NSLPP MEETING HELD ON 06/11/2024

ADDRESS/WARD: 32 Milson Road, Cremorne Point

APPLICATION NO: DA87/24 (PAN-427733)

PROPOSAL: Alterations and additions to a dwelling house including a two-storey pavilion style addition, a spa pool, car parking and landscaping.

Figure 13: Design modifications to minimise impacts on Tree T2

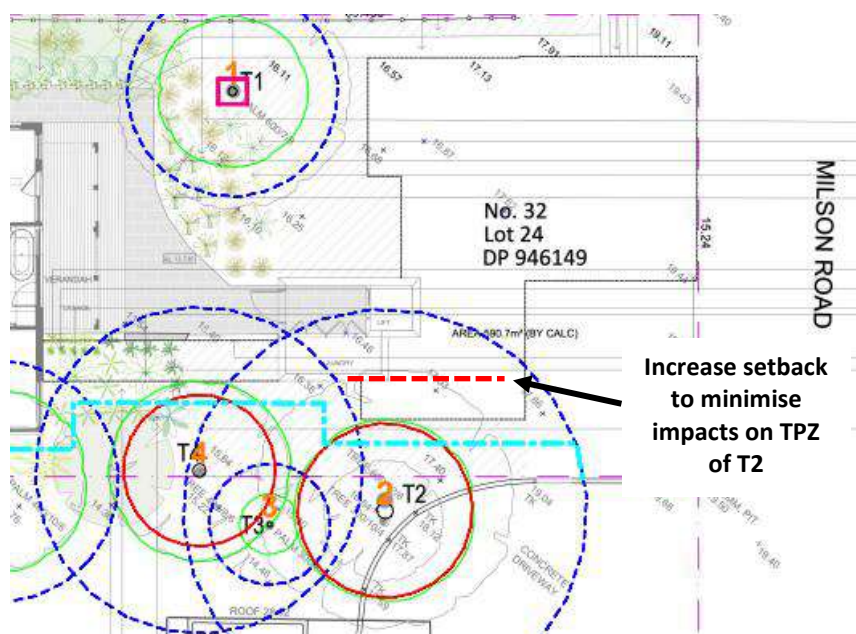
The southern-western corner of the proposed rear addition is likely to affect the tree protection zone (TPZ) of a turpentine tree (*Syncarpia glomulifera*). A deferred commencement condition is recommended requiring the design of the rear addition be modified to minimise the encroachment onto the TPZ of T2 (Turpentine) (**Condition AA1**).

Given that the proposal, as amended by the applicant, has substantially addressed the landscaping concerns, it is recommended that a deferred commencement condition be imposed requiring the design of the rear addition be modified with the setback of the Level 1 southern wall of the proposed rear addition from the common (southern) property boundary with No. 30 Milson Road be increased to 3.1m to minimise the encroachment onto the TPZ of T2 (*Syncarpia glomulifera*) Turpentine (**Condition AA1**).

AA1. The design of the proposed rear addition shall be modified as follows:

- (a) The Level 1 southern wall of the proposed rear addition shall provide 3.1m setback from the southern property boundary with No. 30 Milson Road to minimise the encroachment of the proposed building onto the tree protection zone of T2 (*Syncarpia glomulifera*);
- (b) The internal layout of the rear addition be modified to reflect the design modifications as required in item (a) of this condition;
- (c) The existing ground level of the area affected by the design modifications as required in item (a) of this condition shall remain unchanged;
- (d) Appropriate soft landscaping shall be provided on the area affected by the design modifications as required in item (a) of this condition;
- (e) The arborist report shall be amended in accordance with the design modifications as required by item (a) of this condition and sensitive construction measures be used.

Figure 14: Proposed development and LEP height limit

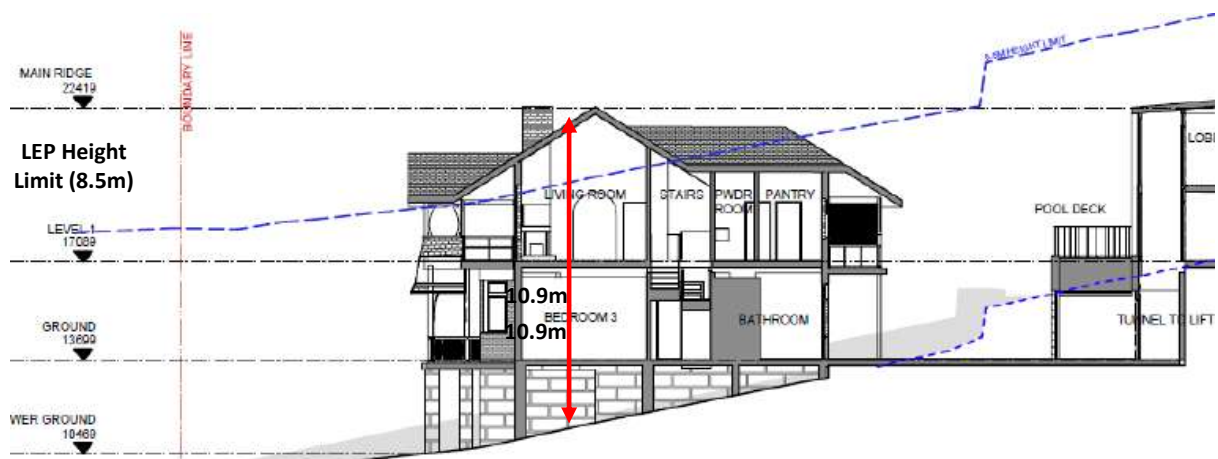
The maximum height of the proposed works within the main dwelling at 10.9m would breach the 8.5m LEP building height control by up to 2.4m as illustrated below:

It is concluded that the building elements above the LEP building height limit would have no material impacts on neighbouring properties and the locality in terms of the built forms within the locality and the amenity of the surrounding properties subject to the imposition of appropriate conditions. There are sufficient environmental planning grounds to justify contravening the building height control.
